ADDENDUM NO. 03

DATE: May 5, 2020

PROJECT: Inglemoor High School Concert Hall + Music Building Project

4 STAIR B 103 - UPPER LEVEL PLAN
SCALE: 1/4" = 1'-0"

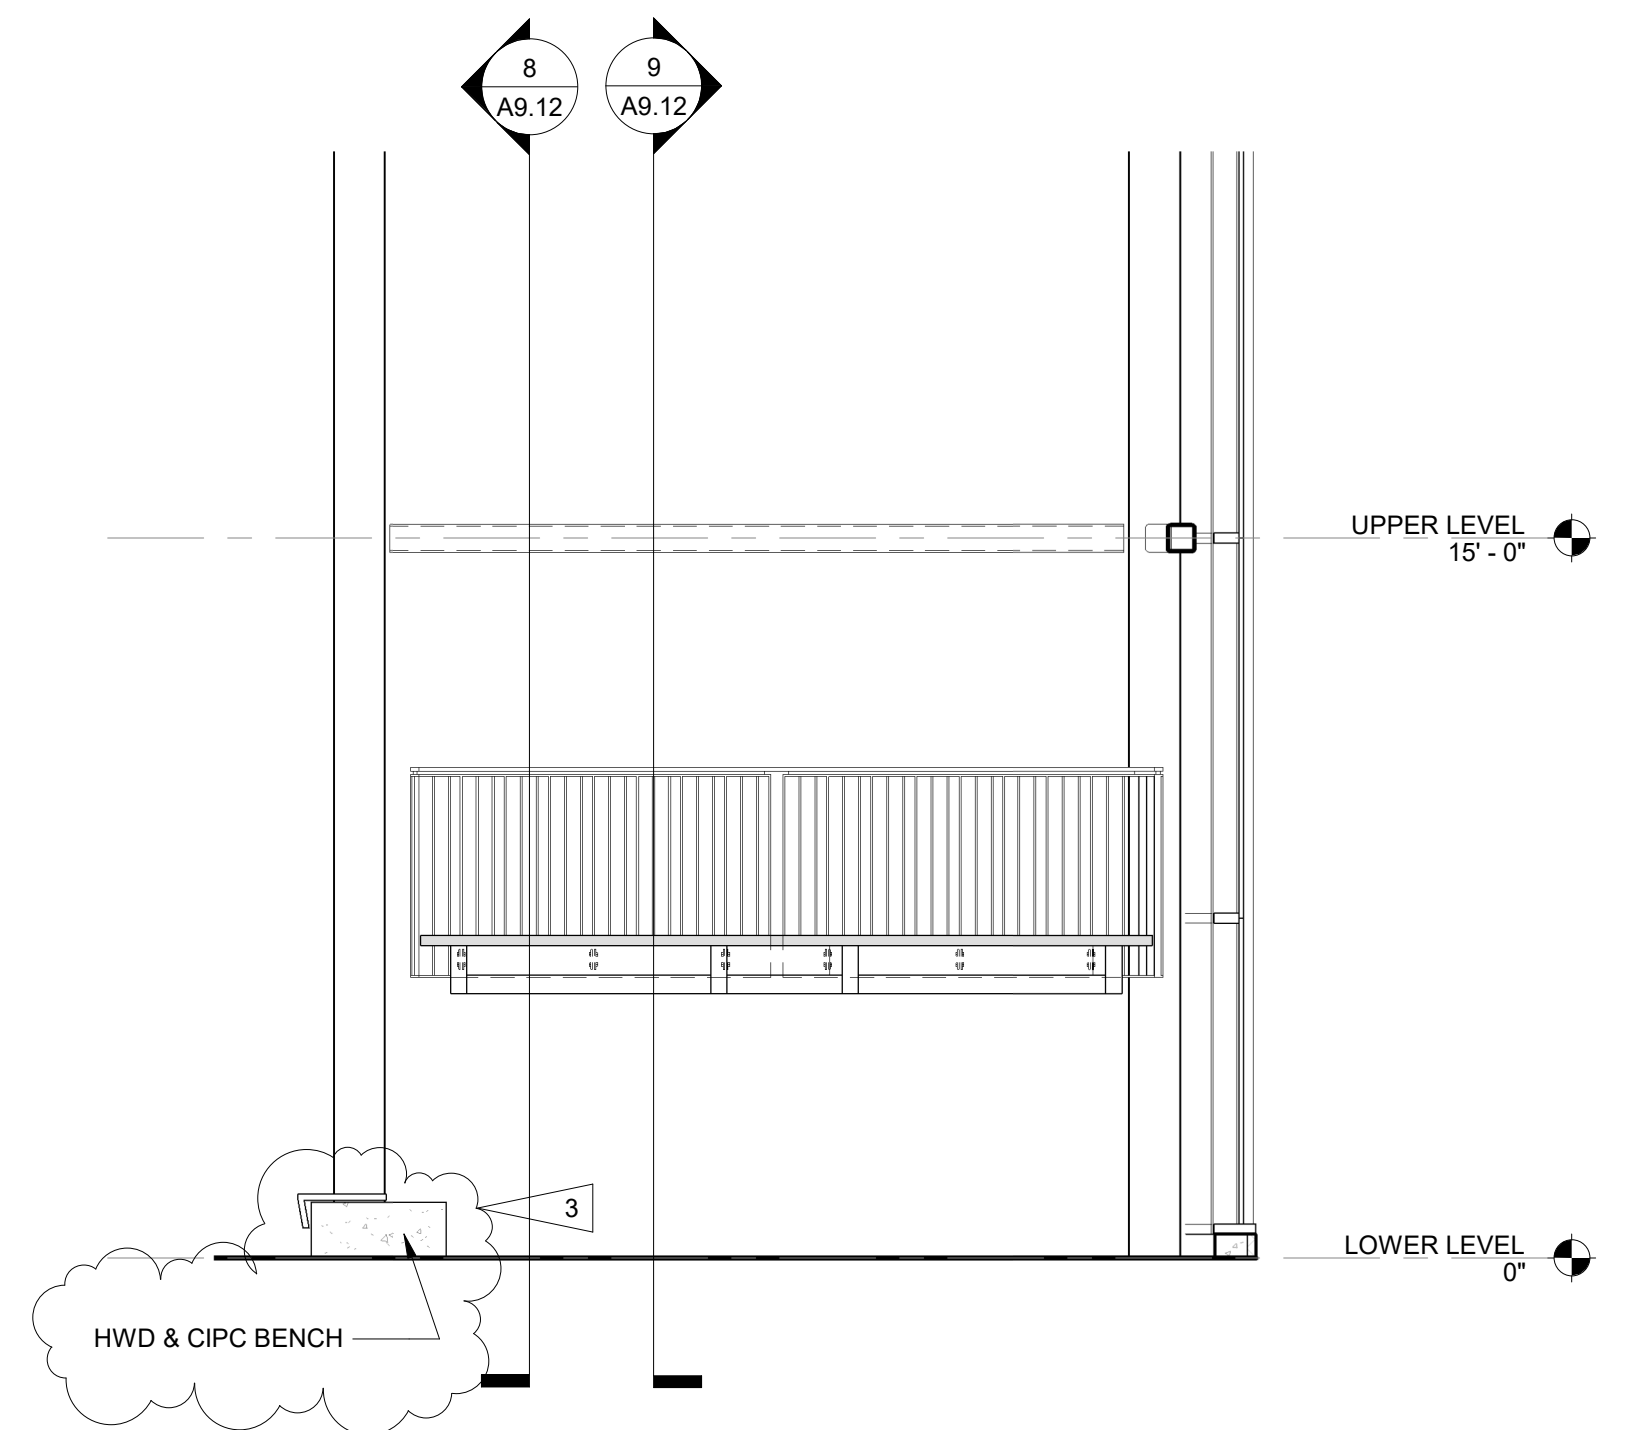
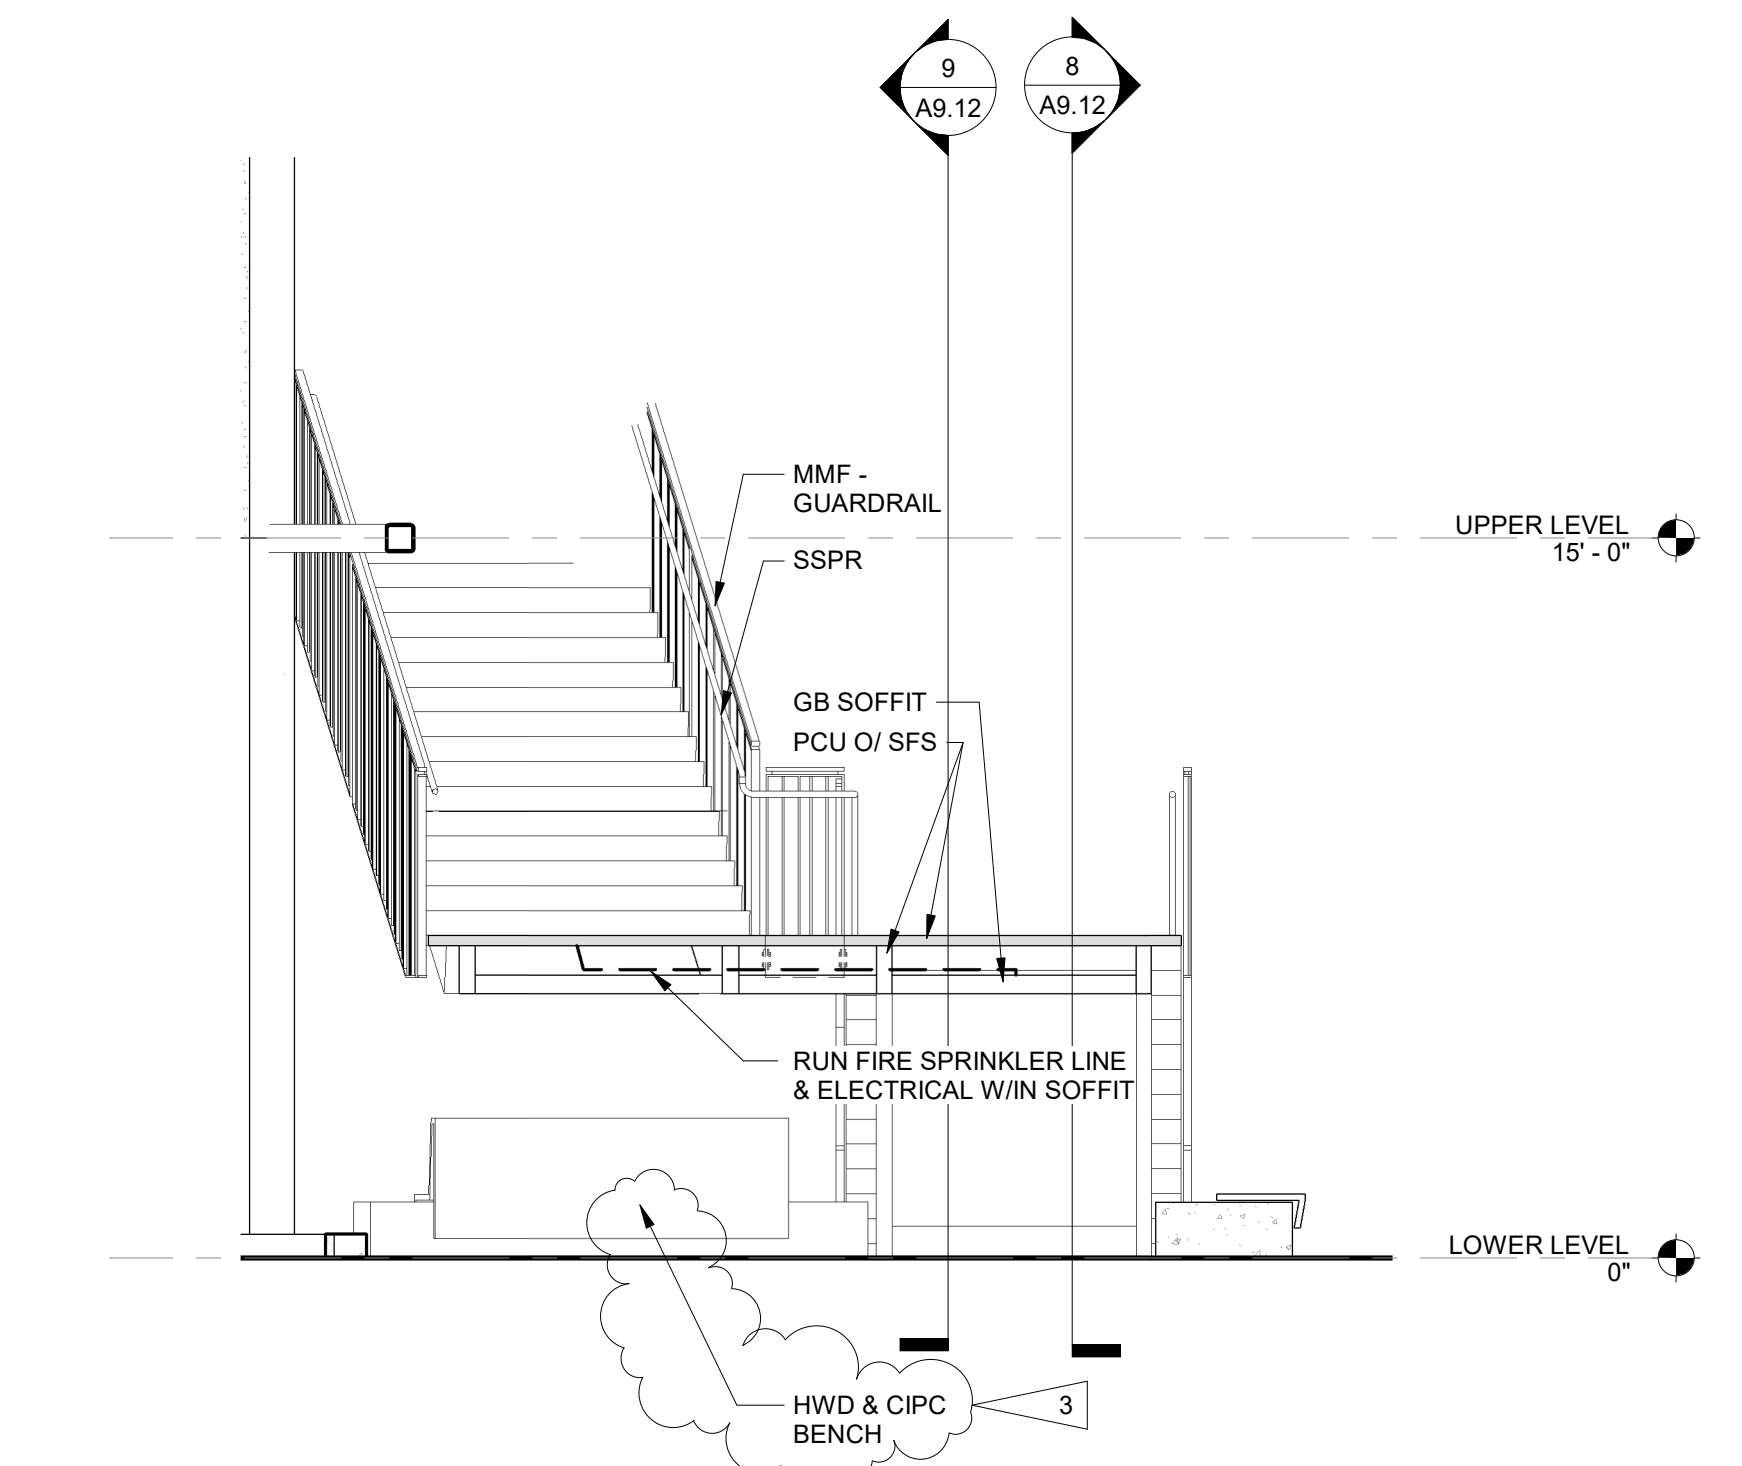
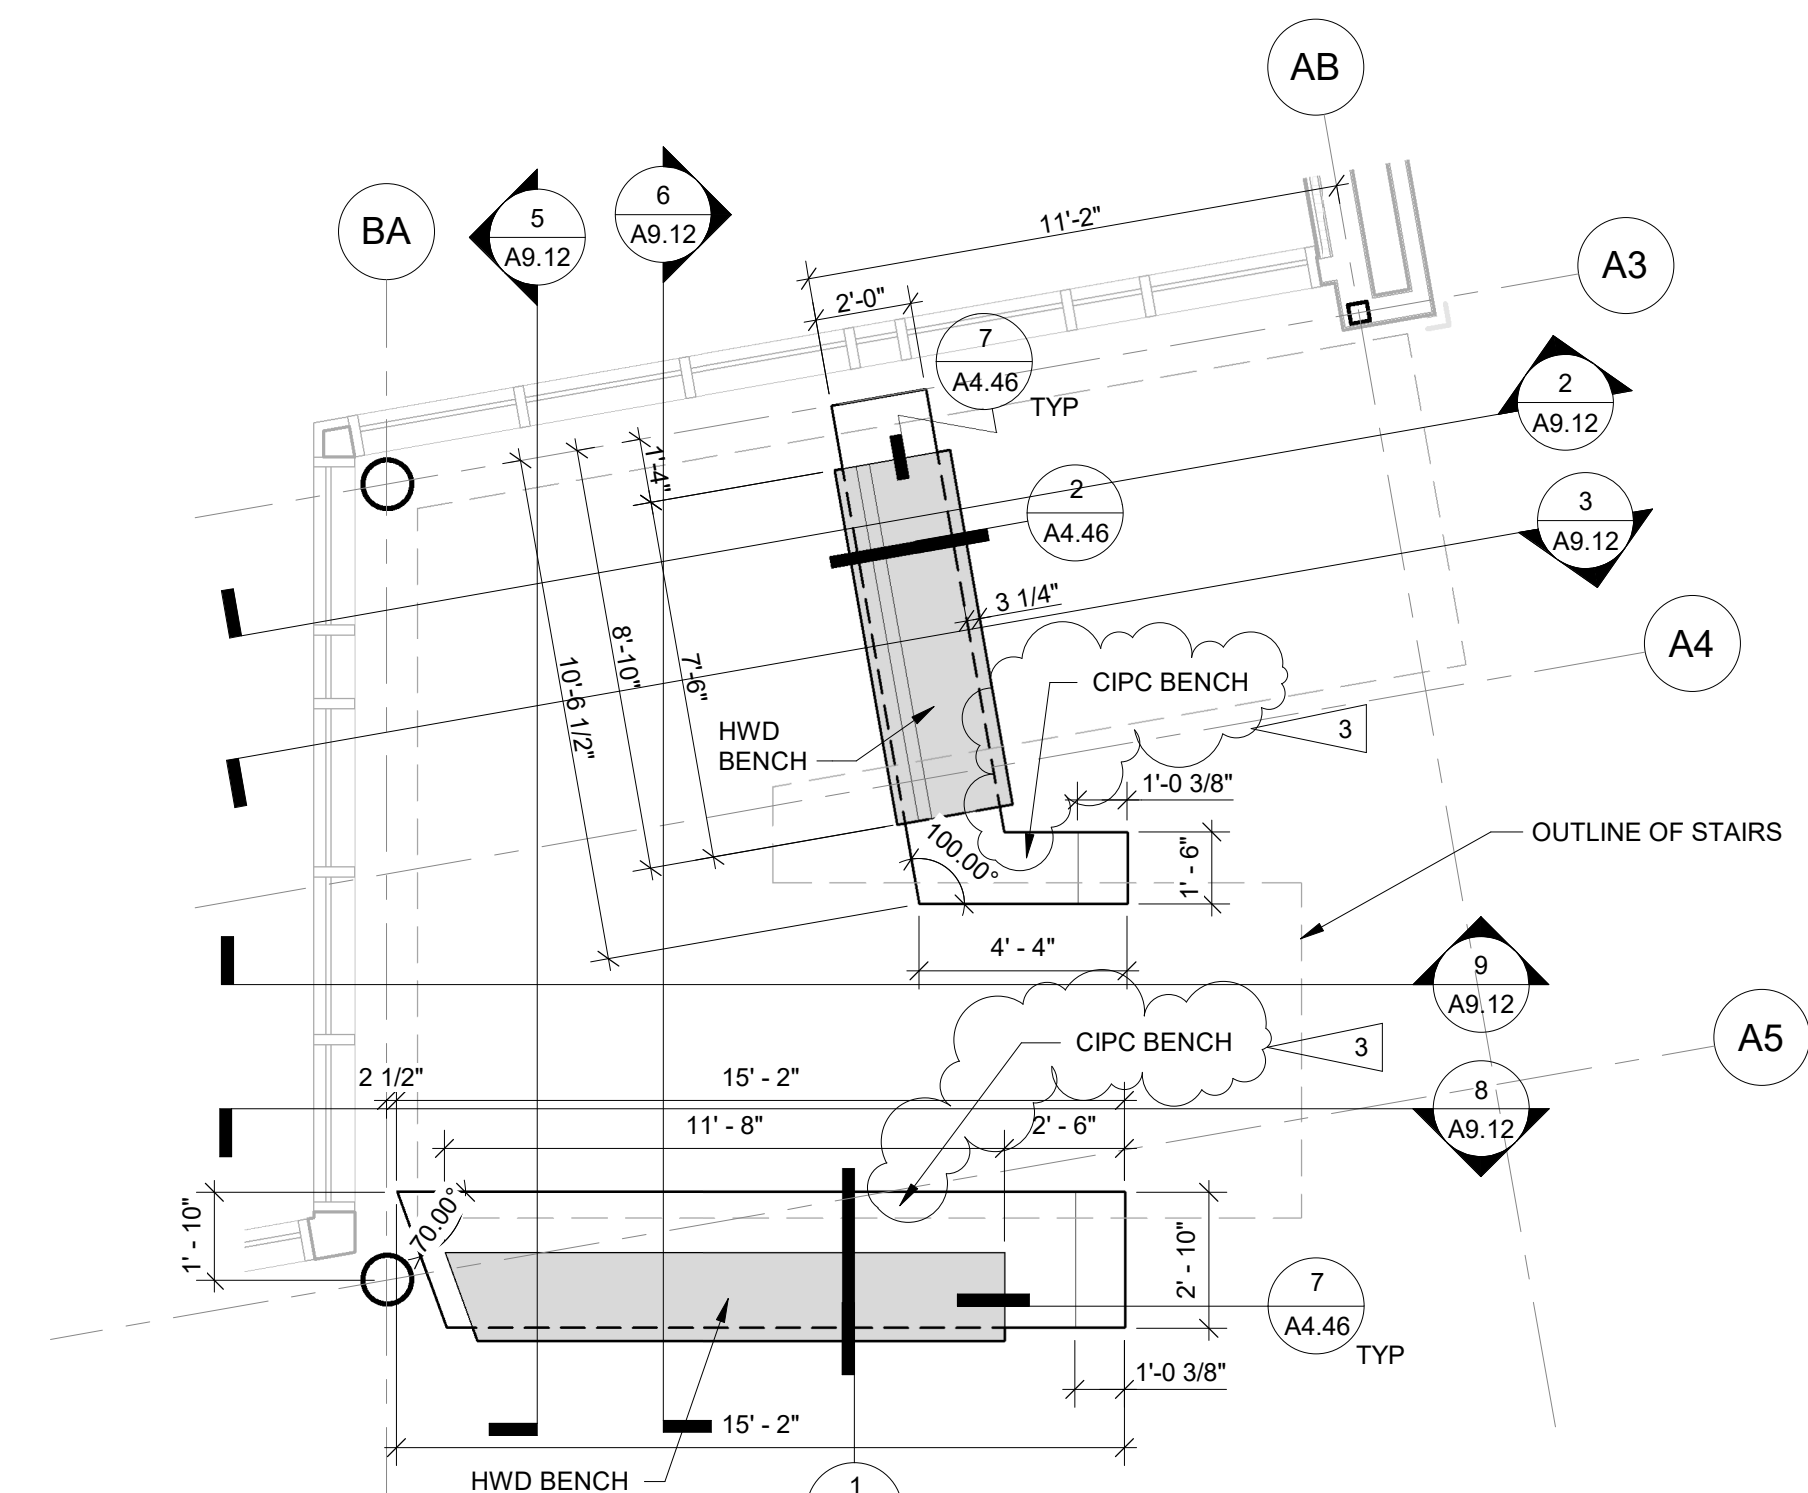
1. On Detail 2, 3, 5, 6, 7, 8, and 9, REVISE per attachment A4.46
